ITEM FOR ENVIRONMENTAL COMMISSION AGENDA

NAME & NUMBER OF PROJECT: Sky Mountain
SP-2021-0079C

REQUEST: Variance request is as follows:
Request to vary from LDC 25-8-341 to allow cut over 4 feet to 16
feet.

**STAFF
RECOMMENDATION:**

**SKY MOUNTAIN
 PLANS FOR SITE DEVELOPMENT**
 CUT / FILL ANALYSIS ON SURVEY TOPO

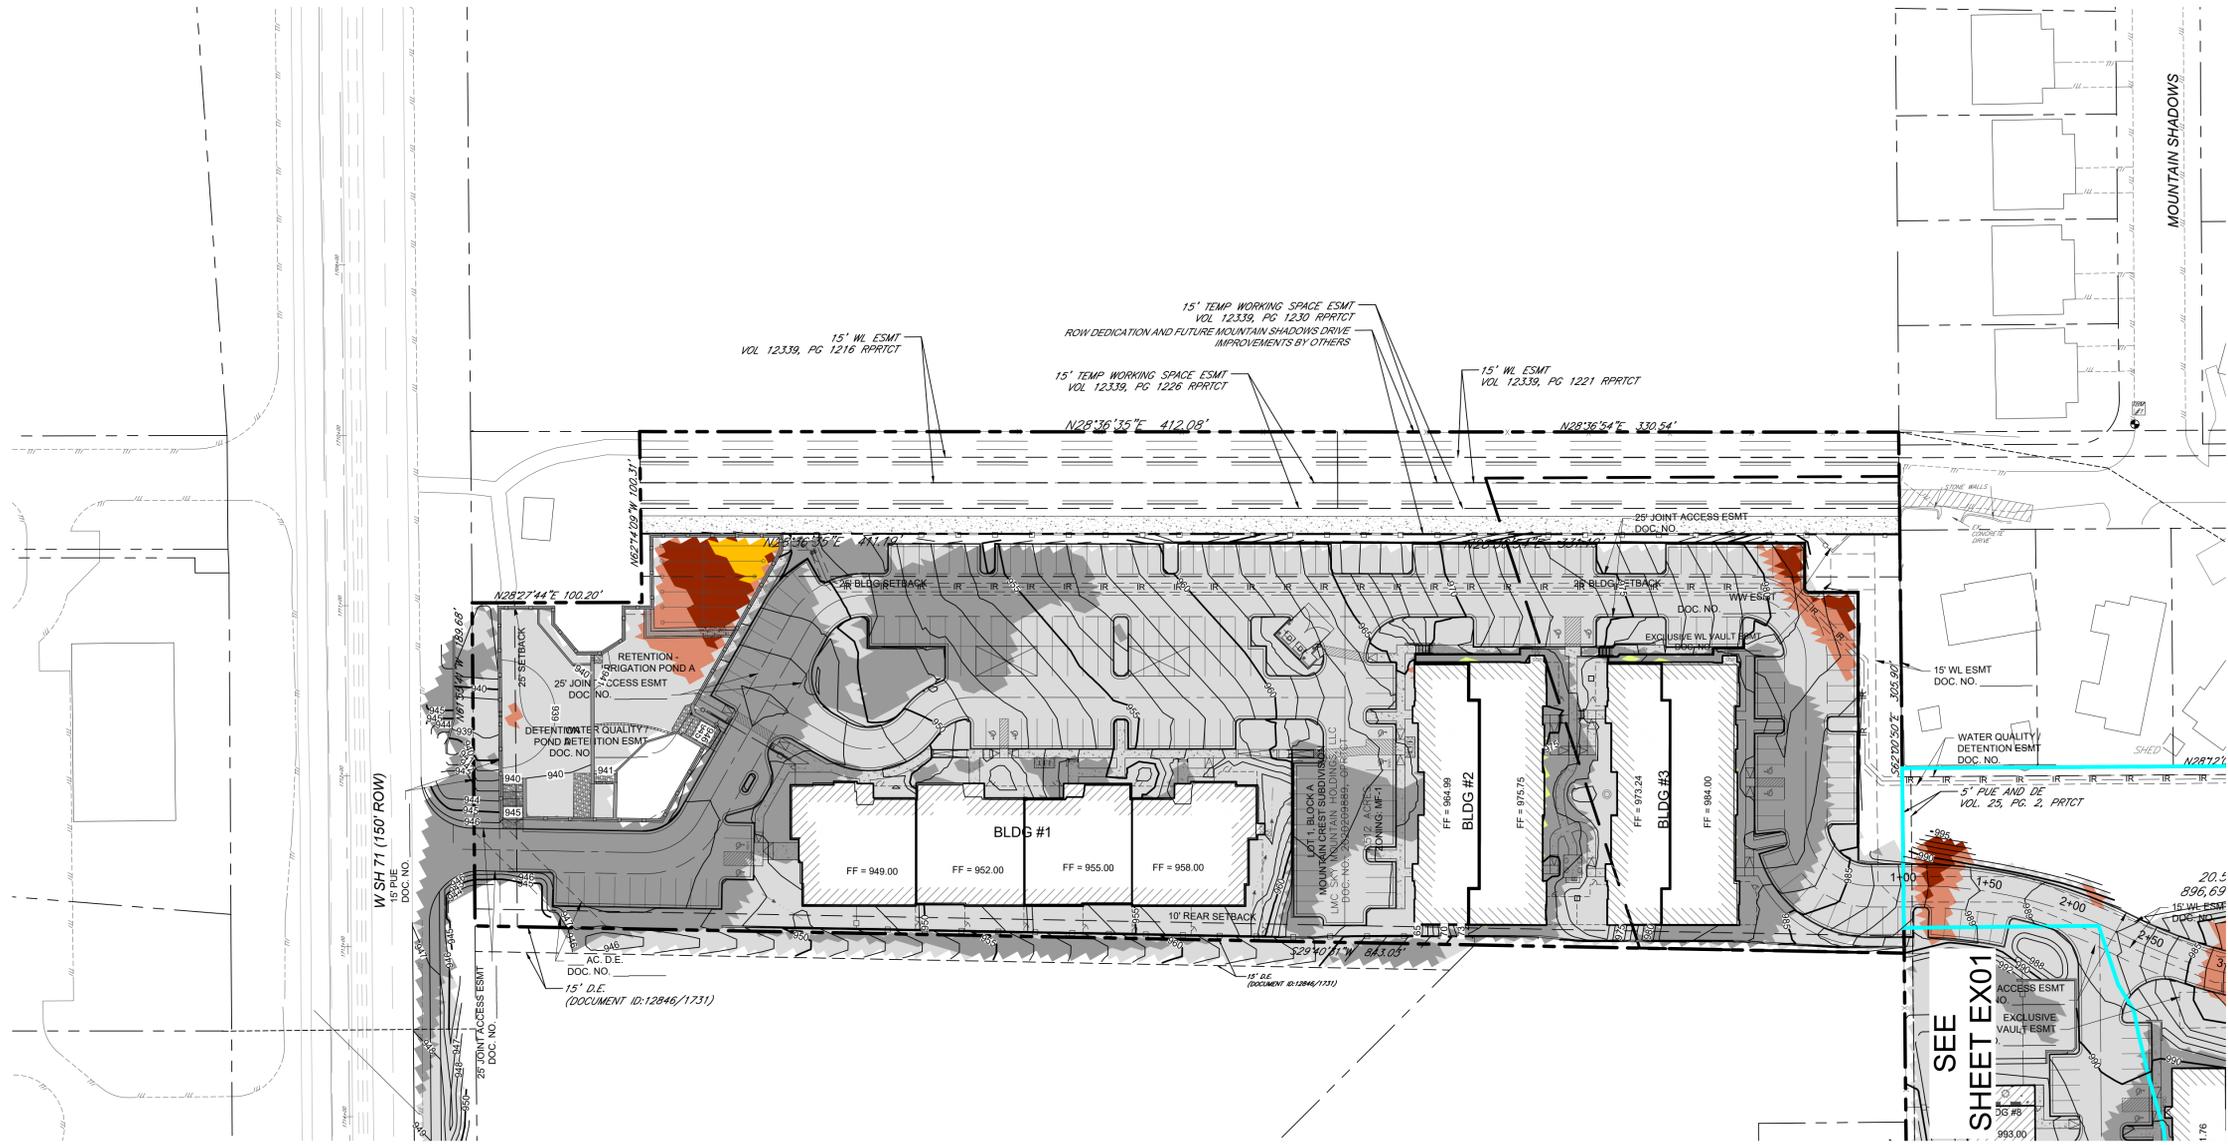
1. All grading over 8 feet will be contained with terracing or engineered walls.
2. Around the perimeter of the limits of construction, and in areas where more than 3' of vertical rise is proposed, 3:1 slopes will have erosion control matting applied immediately after final grade is achieved.
3. Disturbance in the stormwater irrigation fields will be minimized by restricting the LOC and routing the irrigation lines to preserve existing trees to the greatest extent possible.

Yes The proposed grading is the minimum necessary to develop the site. The placement of fill on the property within the subject area created an un-natural embankment that cannot be developed upon. The man-made slopes have a gradient as steep as 50 percent and are steeper than desirable for development. Moreover, the fill contains unsuitable material. The development proposed cut up to 16 feet, which is the minimum necessary to level and stabilize the site.

Staff recommends this variance, having determined the findings of fact to have been met.
